6 May 2016

**SECTION 75W MODIFICATION OF MAJOR CONCEPT PLAN APPROVAL MP10-0118
EDMONDSON PARK**

Figure 1 – Approved Signage Plan as proposed to be amended

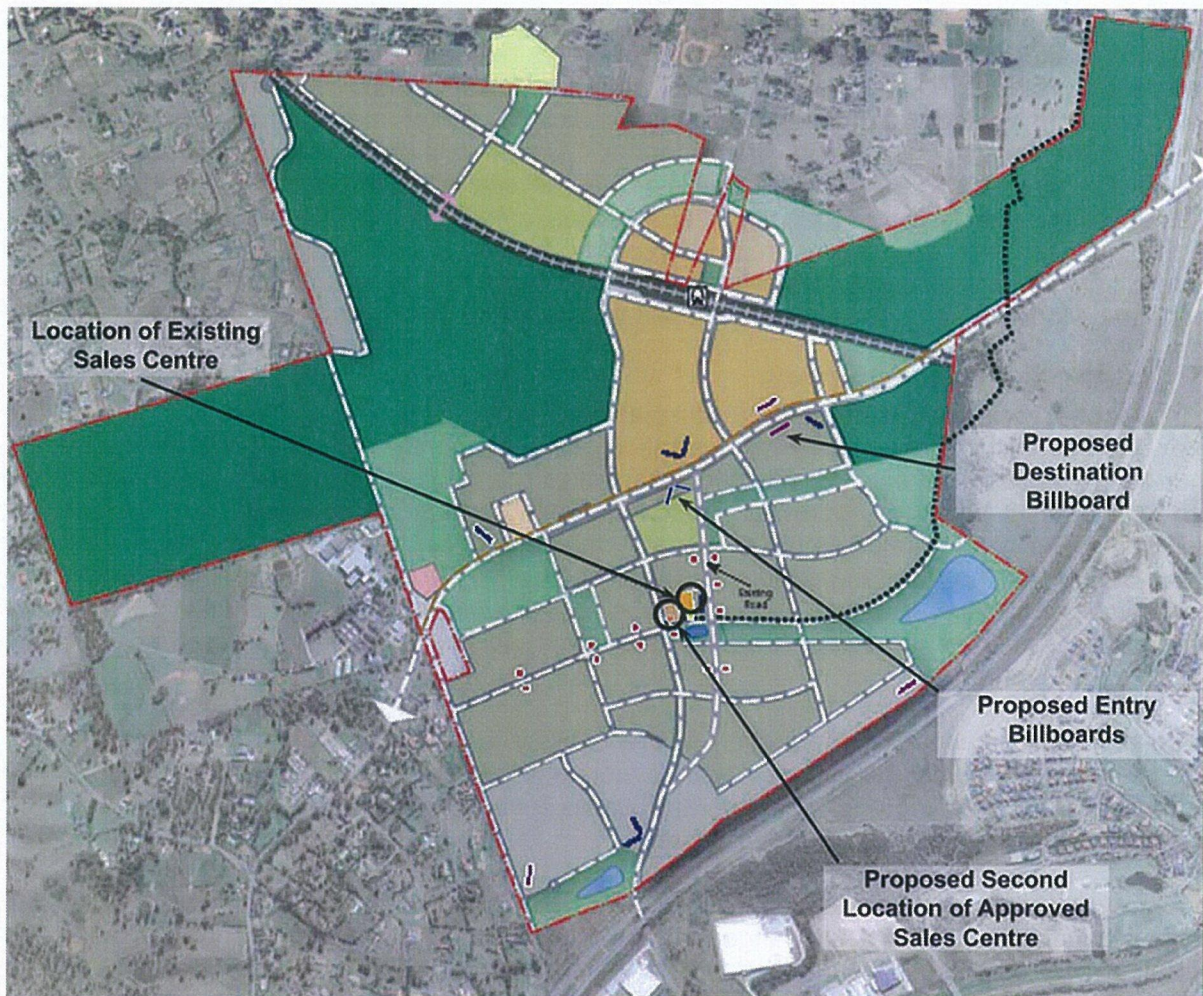
Approval is sought for a second alternate location of the temporary sales and information centre, further to the west of the existing site and adjacent to the approved realigned Macdonald Road (refer to Figure 1 and the Approved Proposed Signage Plan as amended and included at Attachment). The need to relocate the proposed temporary sales and information centre within the site and throughout the life of the project was identified early as part of the original proposal. From a marketing perspective, it makes sense to relocate the temporary sales and information centre within Edmondson Park (now New Breeze) in proximity to the residential stages that are being released to the market.

It is proposed to provide an additional 'entry billboard' (i.e. 6 m wide x 3 m high) and 'destination billboard' (8 m wide x 4 m high) on the southern side of Campbelltown Road on Lot 214 in DP 1186108.

The location of the existing approved signage and signage proposed to be located is shown in Figure 1 and included in **Attachment C**.
